Access Compliance Report

Public Rights-of-Way

(Curb Ramps)

Intersection ID: 15916	Main Street: BRANDON_RD	Cross Street: PEMBROKE_AV	Location: N
ADA ID: AD301EDF9A42	Ramp Type: BlendTrans1	Initial Pass/Fail: Pass	Overall Compliance: No
			Severity Score: 30.25

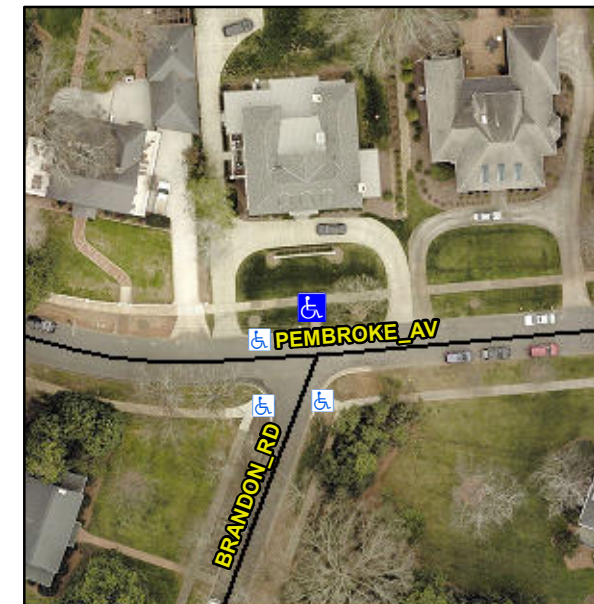
Not Found, R304.2.2-Perp, R304.3.2-Para, R305, R302.7.2, R304.5.4

Compliance	Description	Data	Compliance	Description	Data
N/A	Ramp Length (in)	156.0	Yes	BlendTrans Slope (%)	3.2
Yes	Ramp Width (in)	61.0	Yes	BlendTrans XSlope (%)	3.4
N/A	Flare Type LT	None	N/A	Flare Type RT	None
N/A	Flare Slope LT (%)	N/A	N/A	Flare Slope RT (%)	N/A
N/A	Flare Traversable LT?	N/A	N/A	Flare Traversable RT?	N/A
Yes	Landing Length (in)	64.0	No	DWS Provided?	No
Yes	Landing Width (in)	61.0	N/A	DWS Contrast?	No
No	Landing Slope (%)	5.4	N/A	DWS Length (in)	N/A
Yes	Landing X Slope (%)	3.5	N/A	DWS Full Width?	No
N/A	Landing Curb? (Y/N)	No	N/A	DWS Offset (in)	N/A
N/A	Shared Landing?	No			
Yes	Gutter Ponding?	No	No	Gutter Slope (%)	5.7
No	Gutter Lip Ht (in)	1.0	Yes	Gutter X Slope (%)	3.8
N/A	Painted X Walk1?	No	N/A	Painted X Walk2?	N/A
	X Walk 1 Direction	To S		X Walk 2 Direction	N/A
	X Walk 1 Width (in)	N/A		X Walk 2 Width (in)	N/A
	X Walk 1 Slope (%)	5.3		X Walk 2 Slope (%)	N/A
	X Walk 1 X Slope (%)	5.8		X Walk 2 X Slope (%)	N/A

N/A	Ramp inside XWalk1?	N/A	N/A	Ramp inside XWalk2?	N/A
	Road Slope (%)	5.8		Clear Space?	Yes
	Road X Slope (%)	5.3	N/A	Clear Space to XWalk (in)	N/A
Yes	Any Obstructions?	No	Yes	Storm Grate/Utility Hazard?	No
	Obstruction Type			Storm Grate/Utility Type	
			N/A		N/A
			Yes	Surface Condition? (G/P)	Good
			No	Curb Slope (%)	15.0

Remove & Replace Curb Ramp With Two New Directional Ramps or Equivalent. Remove & Replace Gutter.
